INTER-DEPARTMENTAL REVIEW COMMENTS

SUBJECT: Site Circulation and Access Evaluation
Lombard Commerce Center
Lombard, Illinois

PC 12-13: 401 E. North Ave.

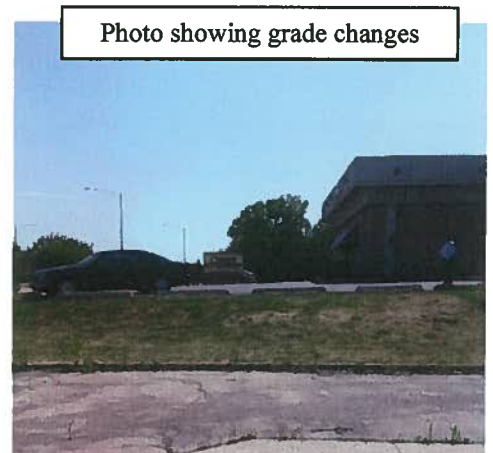
As part of the plan, the petitioner is proposing to include a Dunkin Donuts with drive-through in the easternmost tenant space. Vehicles using the drive-through will queue from the southwest corner of the building and will travel eastbound to the window along the southern building elevation. A one-way bypass lane will be located adjacent to the drive through lane. The pickup window is located on the eastern elevation of the building. Traffic can then proceed to the North Avenue or Grace Street exits. In conjunction with staff, the petitioner amended the original plan submittal to ensure optimal site circulation. The revised site plan included the addition of the 'throat' element that merges the bypass lane and drive-through lane after the drive-through

window. The plan was also revised to provide a notch out of the southeast corner of the building to allow for ease of turn radius.

Figure 1

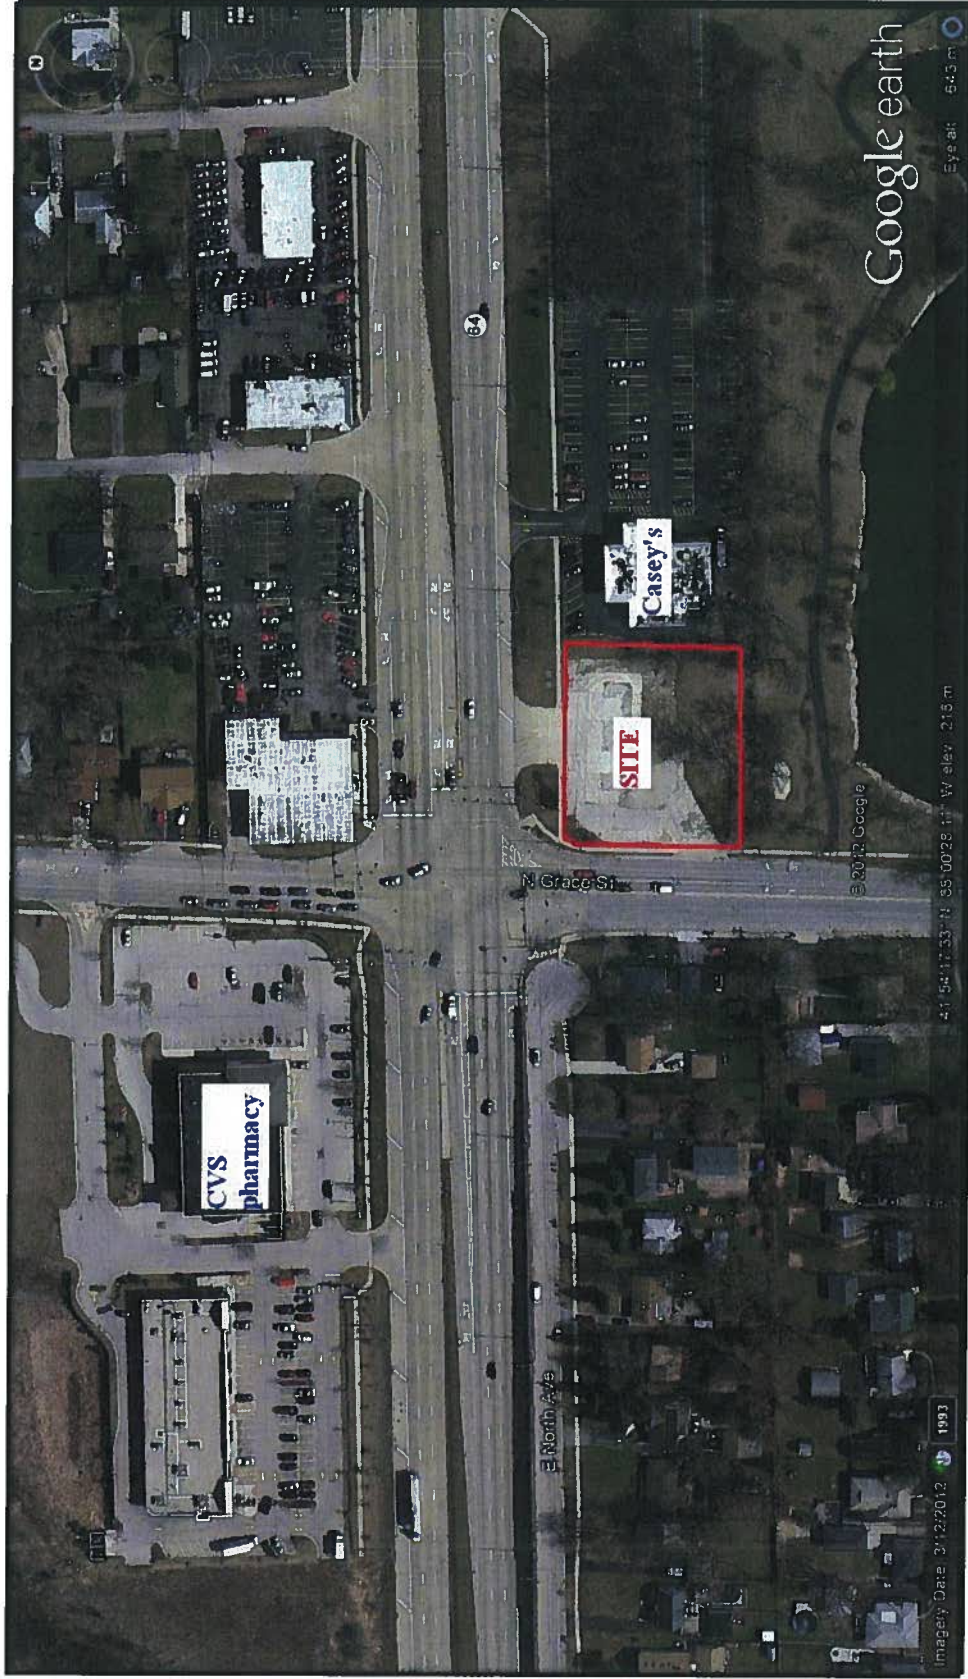
The site is currently vacant and is located on the southeast quadrant of the intersection of North Avenue with Grace Street. **Figure 1** shows an aerial view of the site location. The characteristics of the existing roads that surround the site/development are described below.
